To: John McDonough, City Manager
 From: Angela Parker, Director of Community Development 
 Date: July 2, 2014 for submission onto the July 15, 2014 City Council meeting

Agenda Item: 201301173 5188 & 5208 Roswell Road, 141, 151, 161, 171 Mount Paran Road a request to rezone the subject property from O-I (Office and Institutional District) and R-3 (Single Family Dwelling District to MIX (Mixed Use District) to allow for a new office building, 13 single family homes and an existing 14,625 square foot building to remain., with concurrent variances.

DEPARTMENT OF COMMUNITY DEVELOPMENT RECOMMENDATION

HALPERN ENTERPRISES, INC. - Mt. Paran Rd. & Roswell Rd. (Site Plan)
11 JUNE 2014

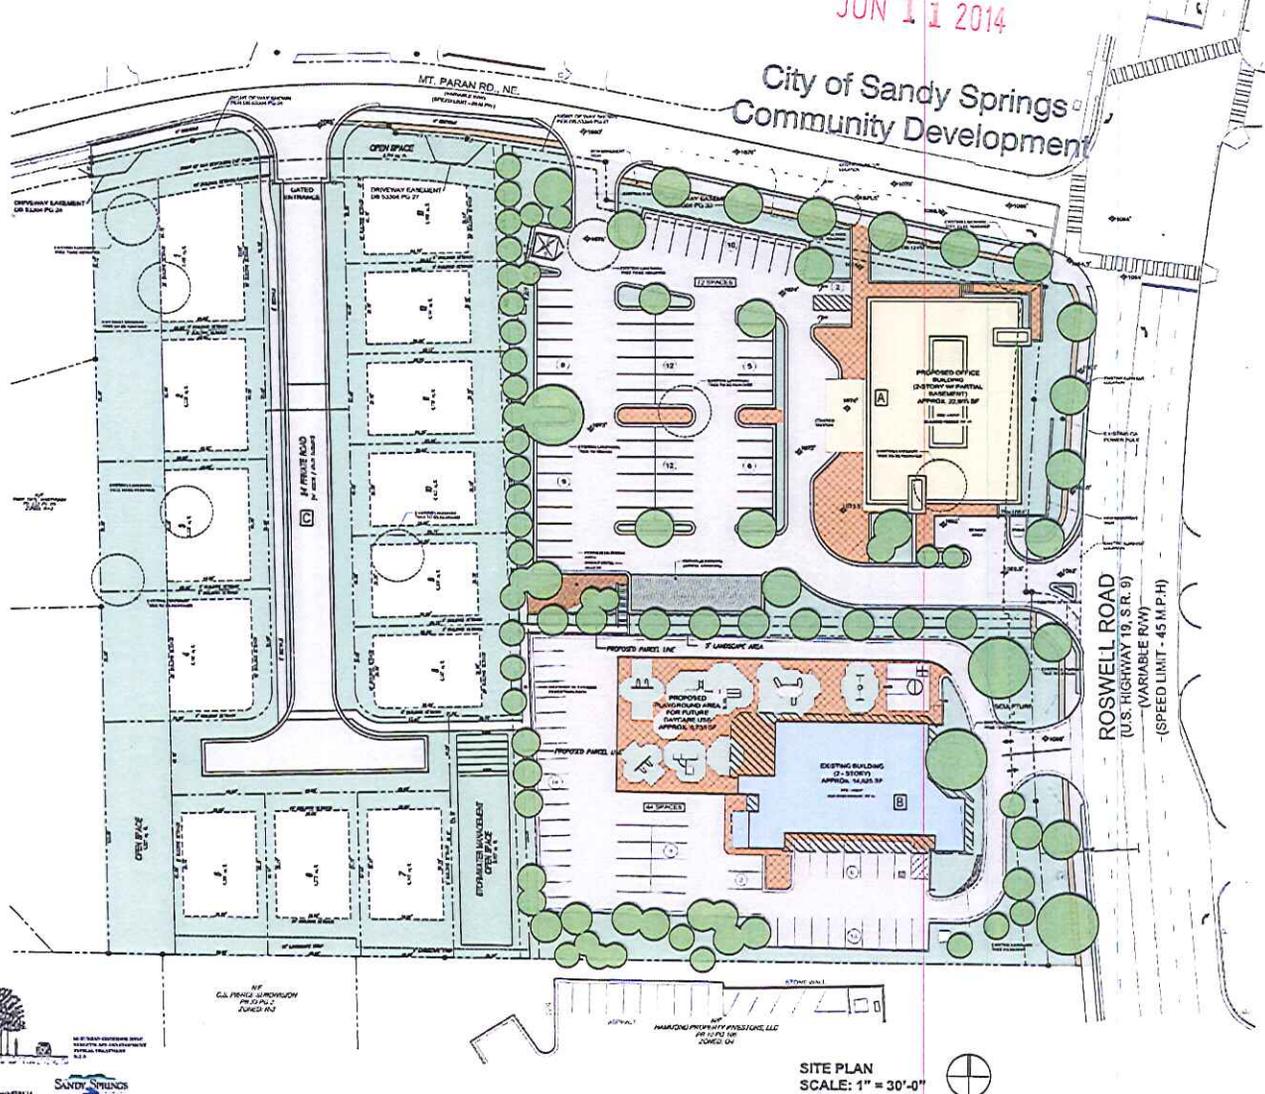
Staff is of the opinion that the reduction of the twenty (20) foot front landscape strip to zero (0) feet to allow the encroachment of the building is not in harmony with the intent of the Zoning Ordinance and could cause a detriment to the public. The applicant is proposing to pull the building closer to Roswell Road. The property is in low intensity commercial area and transitions quickly into the neighborhood. Residential homes and other offices in the area are setback from the road. Additionally the site does not show significant topographical challenges to support the variance request. Therefore, based on these reasons, the staff recommends DENIAL of this variance request.

Staff is of the opinion that the reduction of the ten (10) foot side landscape strip to zero (0) feet to allow the encroachment of the building is not in harmony with the intent of the Zoning Ordinance and could cause a detriment to the public. The applicant is proposing to pull the building closer to Roswell Road and Mount Paran Road. The property is in low intensity commercial area and transitions quickly into the neighborhood along Mount Paran. Residential homes and other offices in the area are setback from the road. Additionally the site does not show significant topographical challenges to support the variance request. Therefore, based on these reasons, the staff recommends DENIAL of this variance request.

Staff is of the opinion that the reduction of the twenty (25) foot side buffer and ten (10) foot improvement setback to a five (5) foot/ten (10) foot landscape strip and a twenty (20) foot building setback is not in harmony with the intent of the Zoning Ordinance and could cause a detriment to the public. The applicant is proposing to eliminate the buffer adjacent to the single family homes. Additionally, the site does not

Staff is of the opinion that the reduction in the fifty (50) foot side buffer and ten (10) feet to thirty-five (35) feet building setback is not in harmony with the intent of the Zoning Ordinance and could cause a detriment to the public. The single family portion of the rezoning is part of a larger mixed use zoning. The applicant is proposing to construct five (5) homes adjacent to three (3) existing homes. The applicant is proposing a fifteen (15) foot landscape strip along the westerly property line. Additionally, the site does not show any significant topographical challenges, size restrictions or shape issues to support the variance request. Therefore, based on these reasons, the staff recommends DENIAL of this variance request.

Staff is of the opinion that the request to reduce the required fifty (50) foot right-of-way to forty-four (44) feet is not in harmony with the intent of the Zoning Ordinance. Private road are required to be built to public standards. Additionally the site does not exhibit any significant topographical challenges to support the variance request. Therefore, based on these reasons, the staff recommends DENIAL of this variance request.

- Interparcel access shall be established throughout site and to adjacent parcels.
- Only one driveway is permitted per every 200 feet of frontage. The minimum driveway spacing for 35 mph street is 300 feet. Driveway(s) shall align with driveways located across the street. Any driveway within 250 of a signalized intersection shall be right-in, right-out.

It appears from the site plan that sidewalks are proposed along the frontage of the property on both Roswell Road and Mt. Paran Rd. Landscaping and streetscaping should be designed in such a way as to ensure adequate line of sight at the driveways.

HALPERN ENTERPRISES, INC. - Mt. Paran Rd. & Roswell Rd. (Elevations)
12 MAY 2014

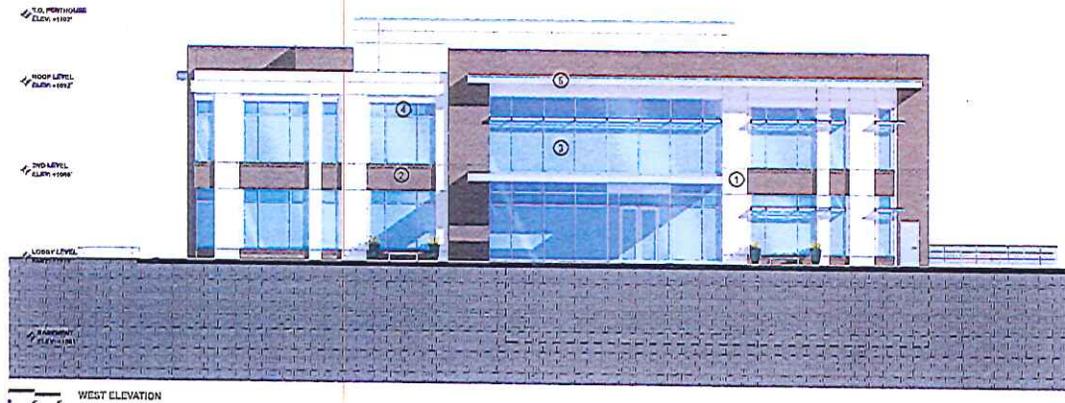
We believe the proposed office building at the corner of Mt. Paran and Roswell should be consistent with the surrounding neighborhoods and have a more traditional rather than modern appearance. We would like to understand more of the details surrounding the proposed daycare facility. Is the development contingent on the daycare facility taking the space? Where will the playground be situated and how will it be screened or buffered from the east side of the proposed residential development? We would like to see whatever is planned for this facility to be part of the rezoning rather than a private arrangement.

1. The proposed new 25,000 square foot commercial building needs to be redesigned to use compatible neighborhood scale architecture as stated in the Glenridge Node requirements where this building is located. We will need to know the new proposed elevations as this is not noted on the current site plan.

2. The proposed commercial building needs to be redesigned to fit in with the look of the neighborhood with a more traditional, upscale feel instead of the current glass, modern, downtown look in the plans.

A LANDSCAPE PLAN
LS-1 SCALE: 1"=20'-0"

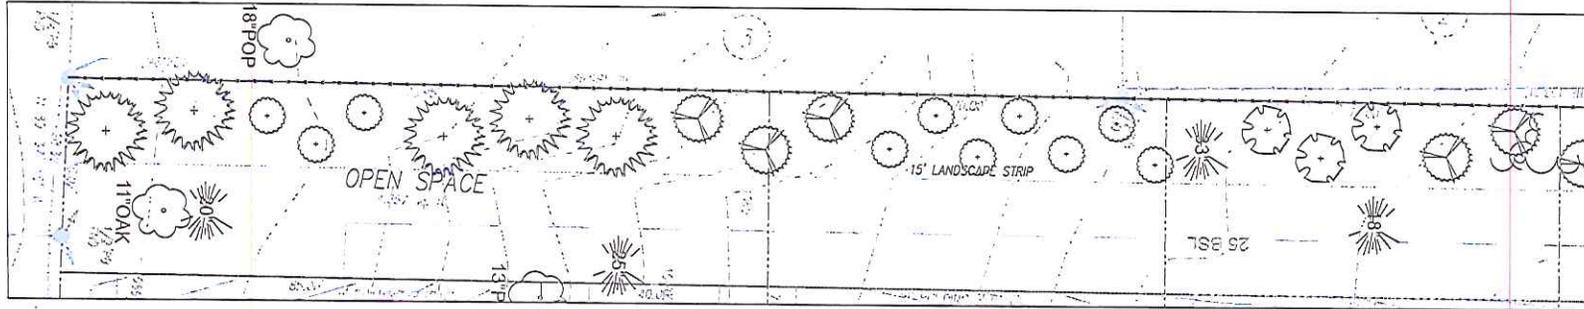
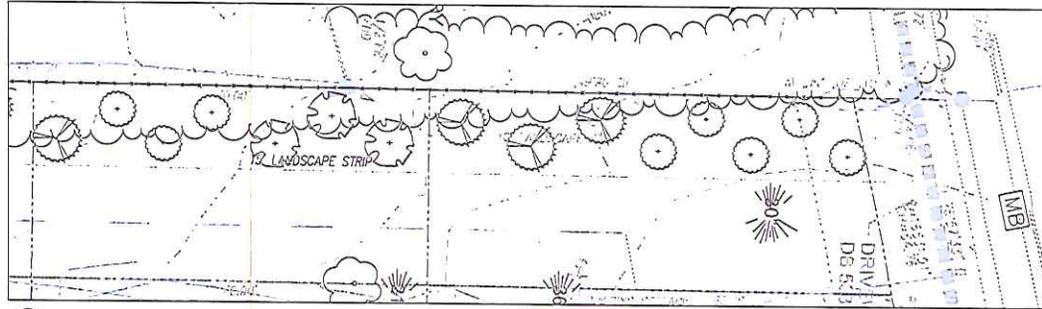
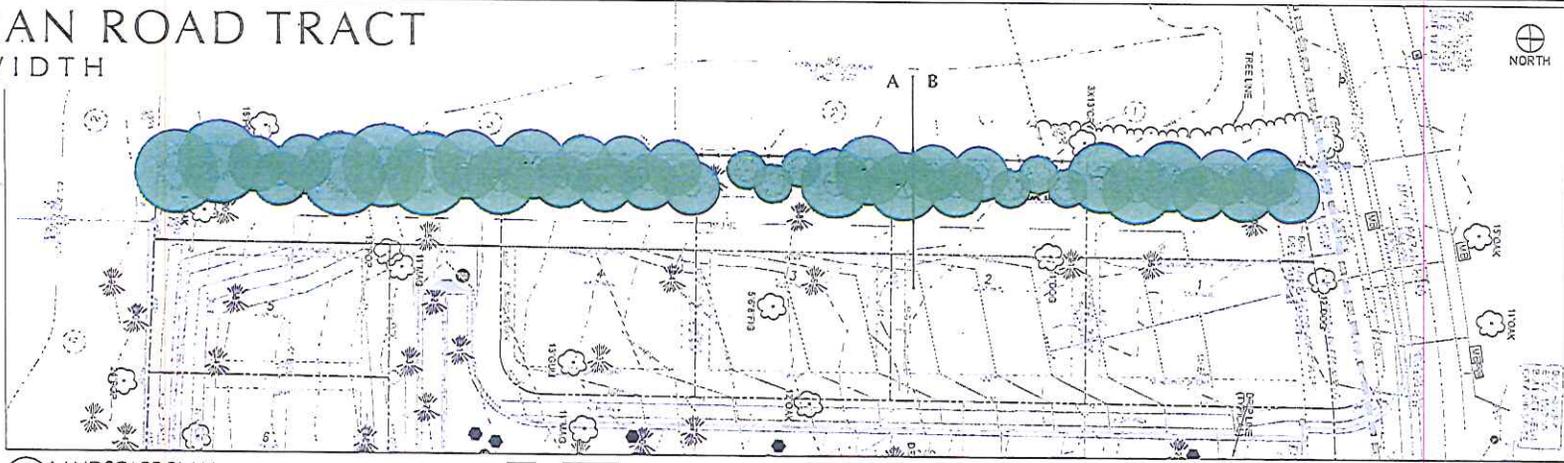
A detailed buffer plan is needed for any portion of the parcel that abuts Park Gate Court, Silverwood Road and Mt. Paran Road. Since these plans are so important to the neighbors, they should be submitted for the packet prior to the PC meeting.

All buffer plans should include the type of tree, size and number. A variation of species is encouraged to provide aesthetic interest associated with high end landscape design.
